**E3647A-02**

**S E R V I C E N O T E**

**E3647A DC Power Supply**

**Display went off during power On.**

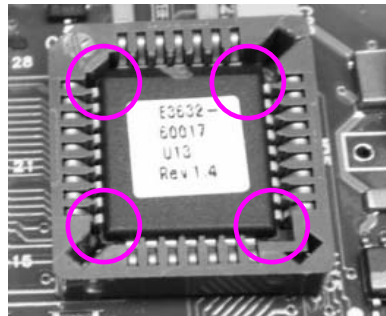
When the unit is power ON, the display went off immediately.

1. Upon turn on the power supply, if the symptoms are as follows:
  - a. Display light up and then become blank with fan running
  - b. Display light up and hang with fan running
2. Turn OFF the power supply.
3. Remove the existing EPROM and replace with a known good EPROM.
4. Refer to the reference designator of EPROM according to model:

5. Turn ON the unit again and see if the symptom disappears.
6. If the symptom still occurs, turn OFF the unit.
7. Return the unit to factory for Failure Analysis.
